ILLINOIS POWER COMPANY

Subject: Clinton Power Station
Fire Protection - Fireproofing of
Division 2 Switchgear Ducts

Justification for Not Fireproofing Division 2 Switchgear Ducts
Safe Shutdown Analysis

SWITCHGEAR HEAT REMOVAL SYSTEM P&ID

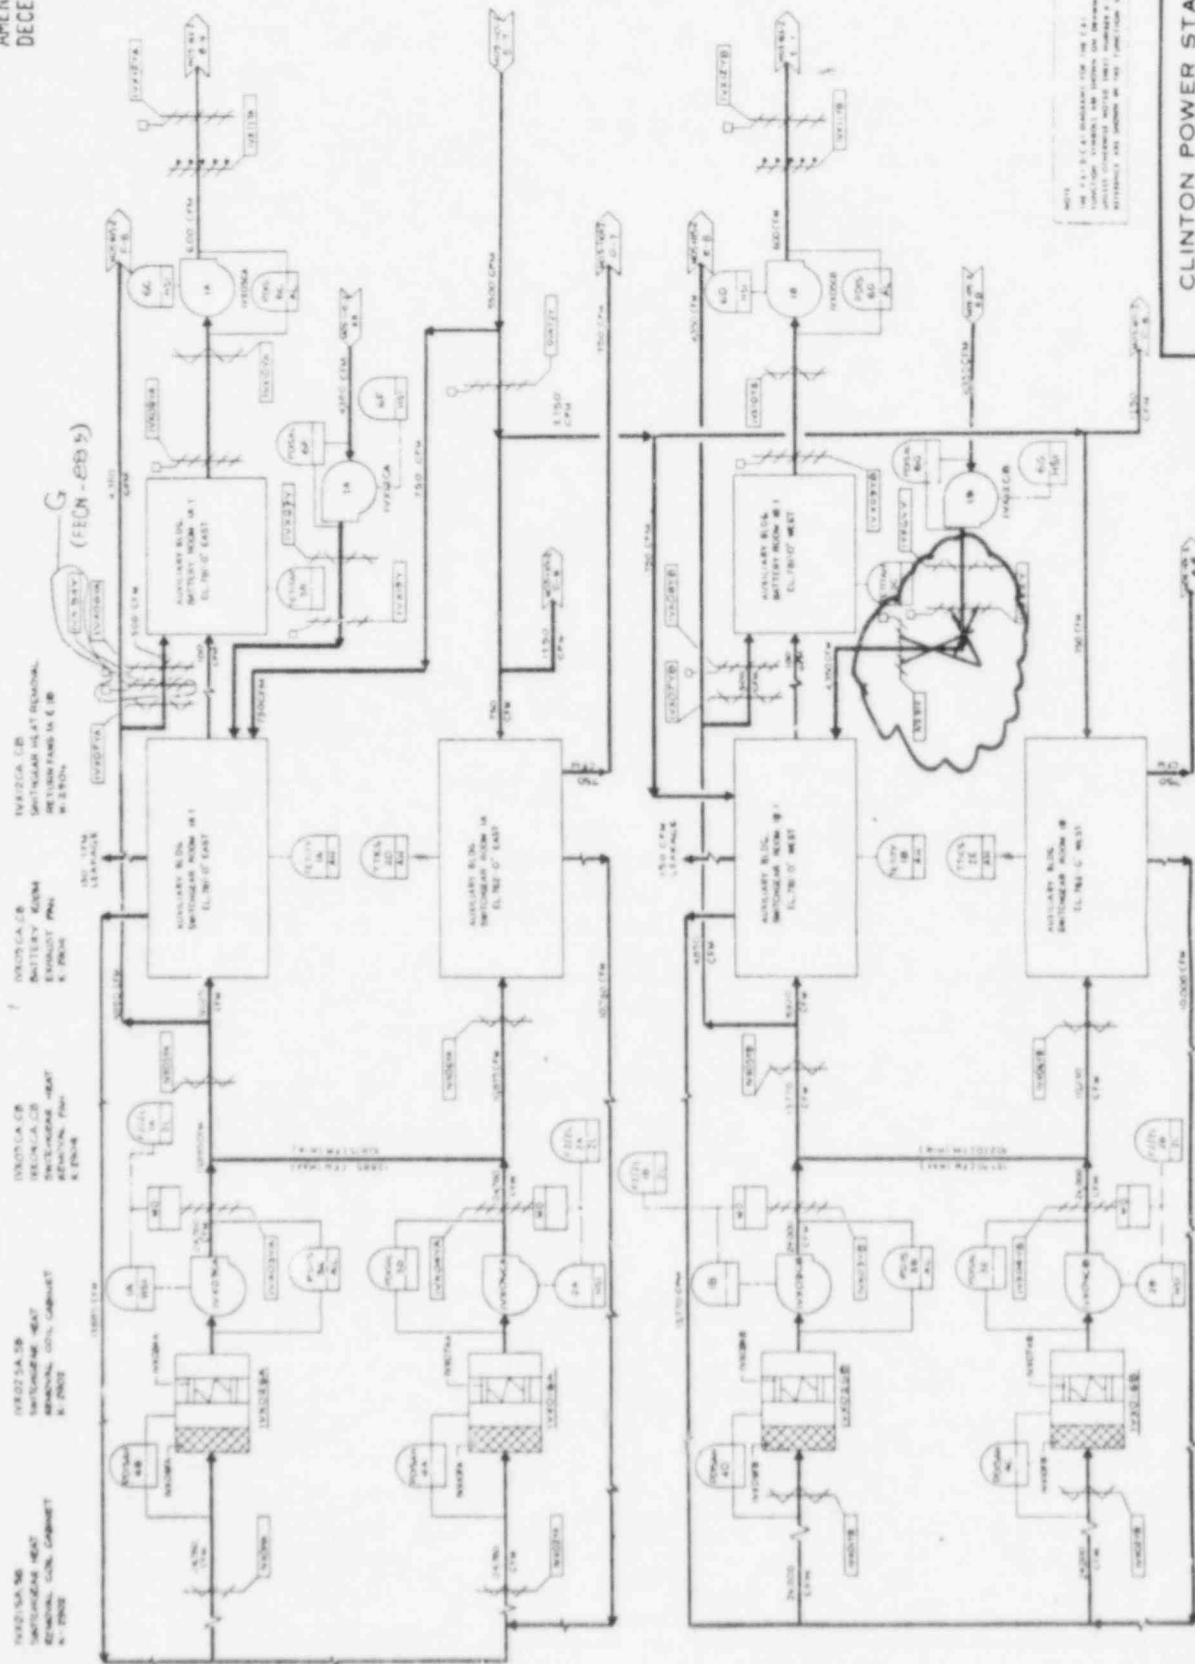
- ° When the duct temperature reaches 135°F, the fusible links of the dampers in ducts leading to the Division 2 Cable Spreading Room (dampers 1VX18Y and 1VX92Y shown on the page 3 of 6 figure) and back to the Division 2 Switchgear Room (dampers 1VX22Y and 1VX91Y shown on the page 3 of 6 figure) would melt and close the dampers. The fusible links currently installed are rated at 165°F. IP will remove these links and replace them with 135° fusible links for the four affected fire dampers.

CLINTON POWER STATION
FINAL SAFETY ANALYSIS REPORT
FIGURE 9.4-6
SWITCHGEAR HEAT REMOVAL SYSTEM P&ID
(SHEET 2 OF 4)

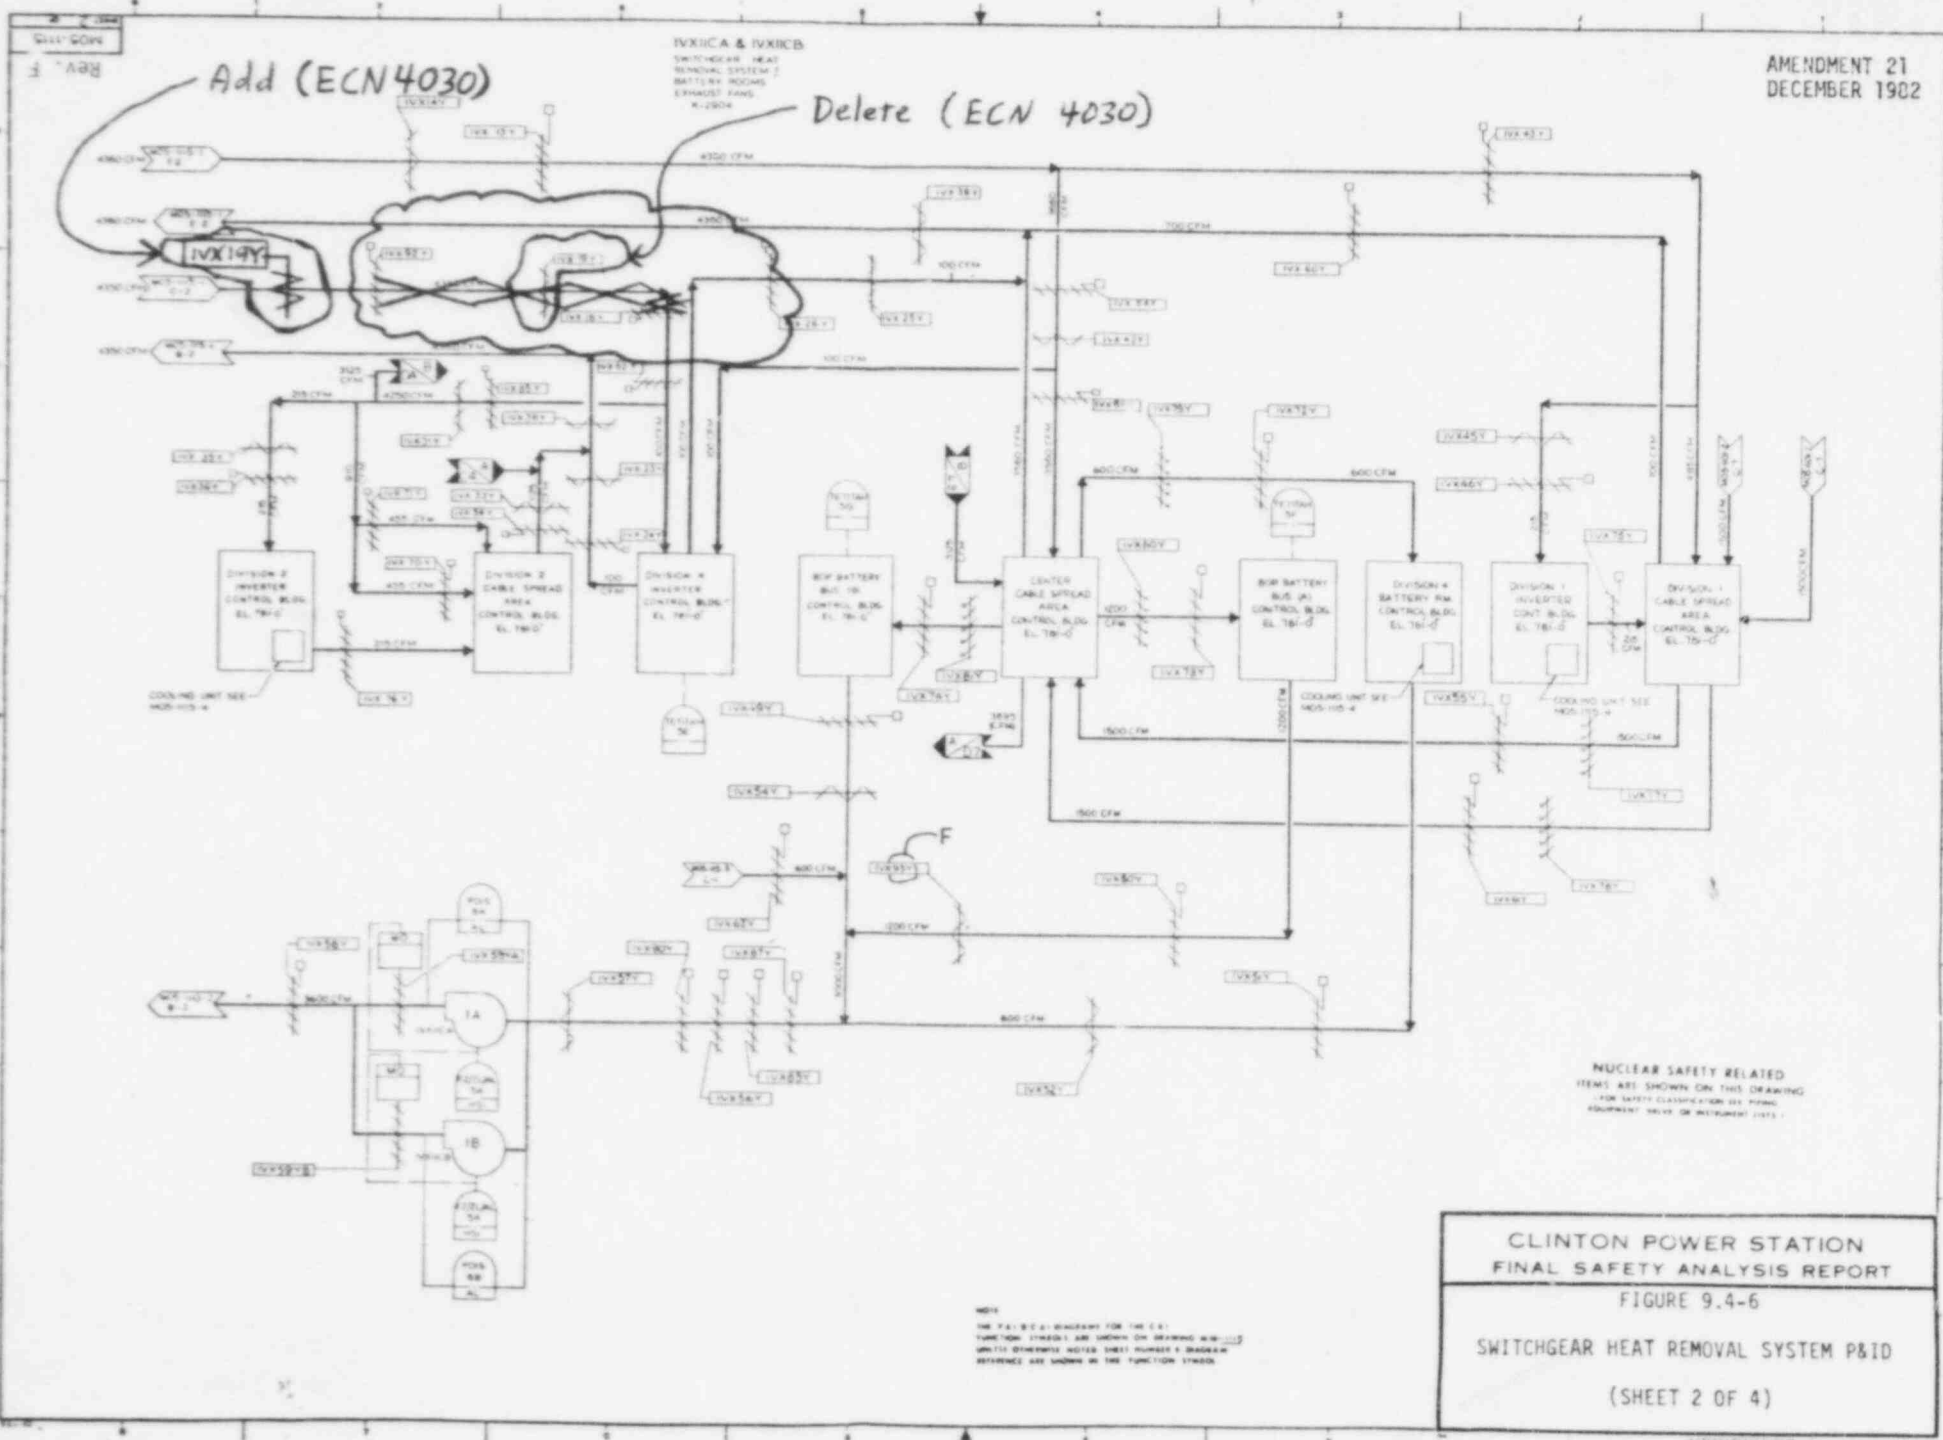
The following is the justification for not requiring fire wrap for the Division 2 Switchgear Room HVAC supply and return duct. Further justification for plant safe shutdown from a fire in the affected fire zone was provided in Section 3.1.2 of the Safe Shutdown Analysis (SSA) submitted to the Staff on September 6, 1985. The affected fire zone is Fire Zone A-2n, which is the Division 1 Switchgear area at elevation 781'-0" of the Auxiliary Building (see FSAR Figure 9.4-6 provided as pages 5 and 6 of 6 for identification of the portion of the Division 2 duct in Fire Zone A-2n).

X - Portion of Div. 2 Duct in Fire Zone A-2n
